CENTRAL ZOO AUTHORITY
MINUTES OF 61ST MEETING OF EXPERT GROUP ON ZOO DESIGNING

Thursday, 21st MAY, 2015

CONSTRUCTION OF STUMPTAILED MACAQUE ENCLOSURE

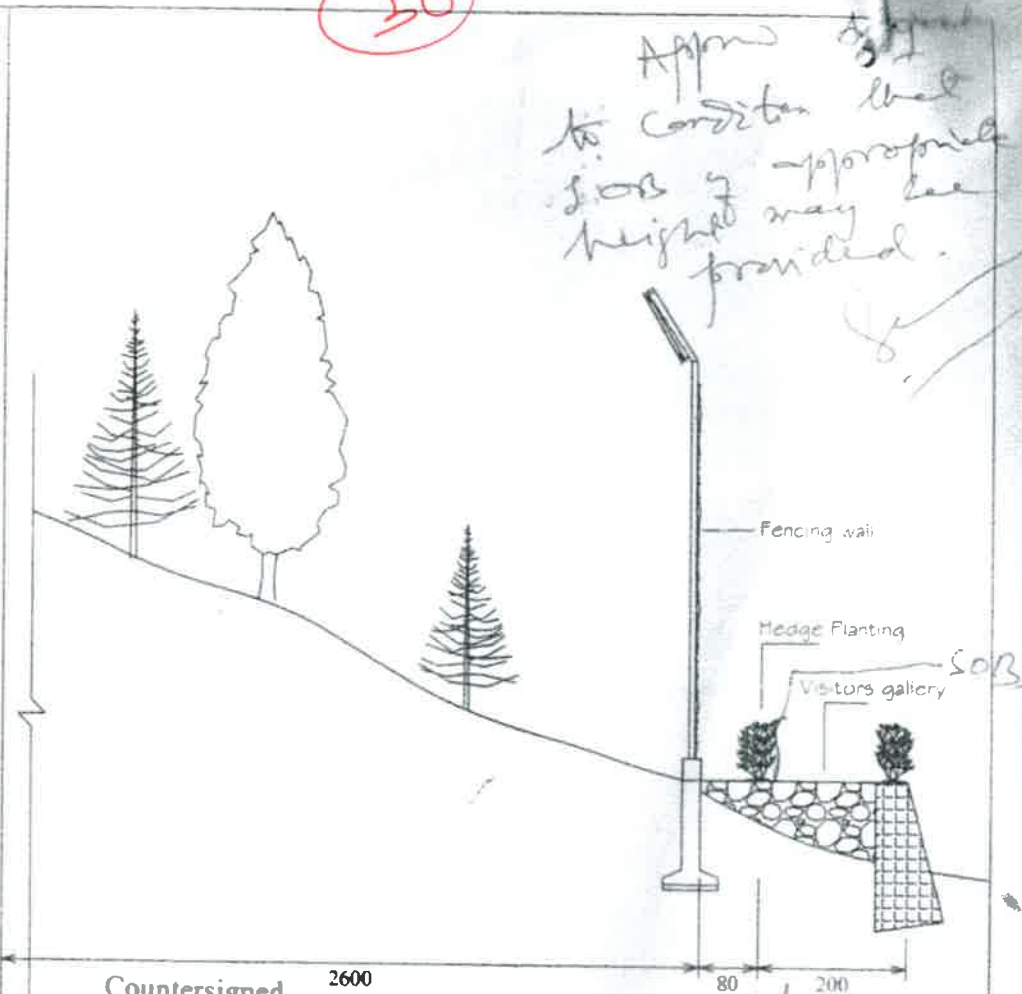
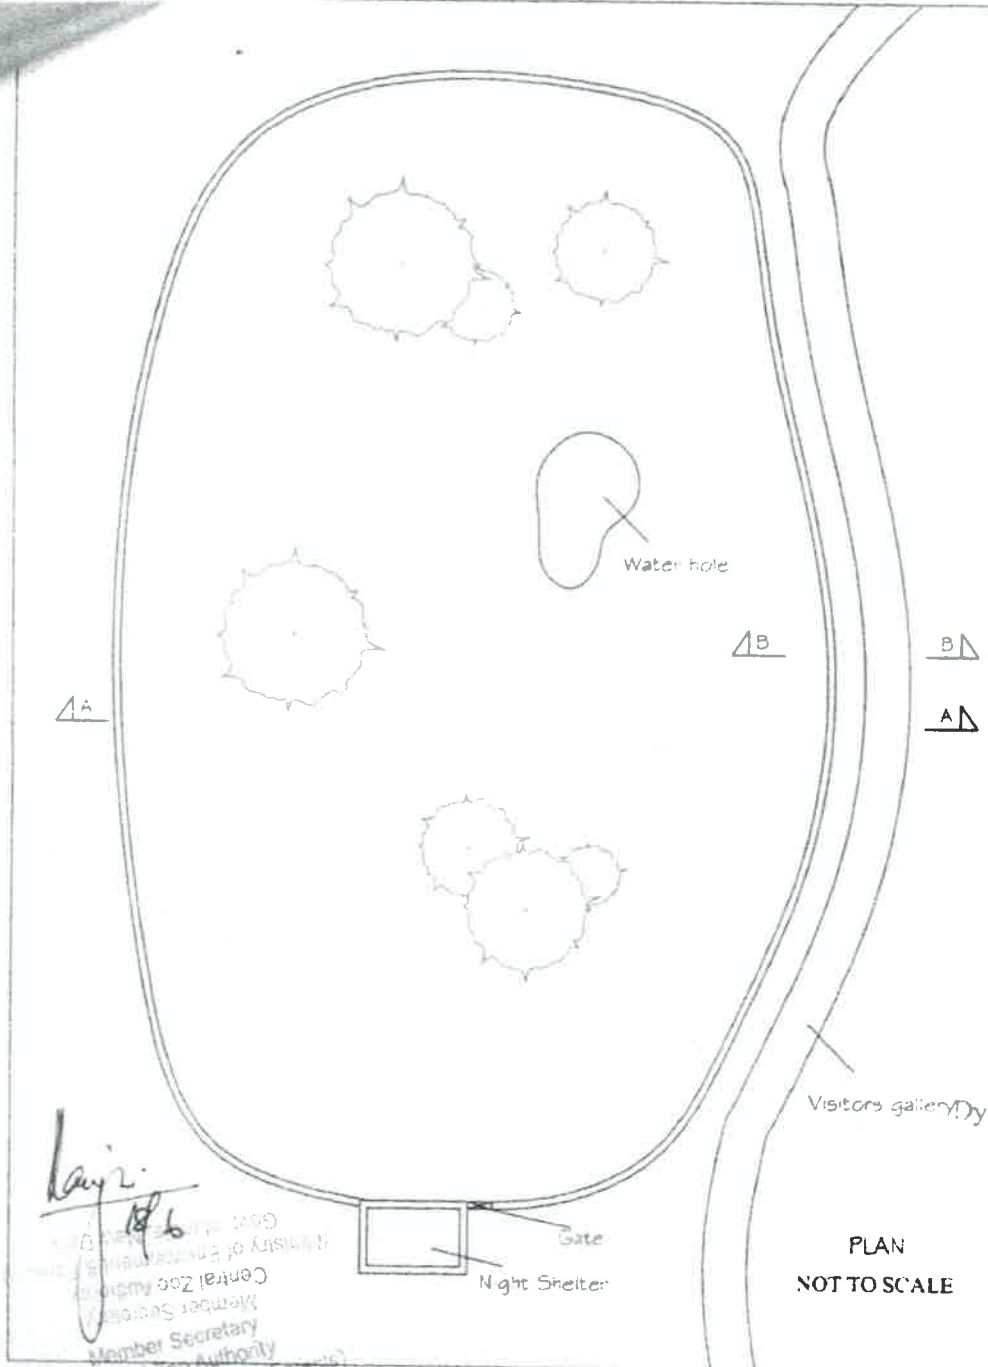
a. **Revised design for construction of exhibit for Stump tailed macaque:-**
   Members on scrutiny of the design, approved the same subject to condition that stand off barrier of appropriate height may be provided.

Approved
to condition that
SOB of appropriate
height may be
provided.
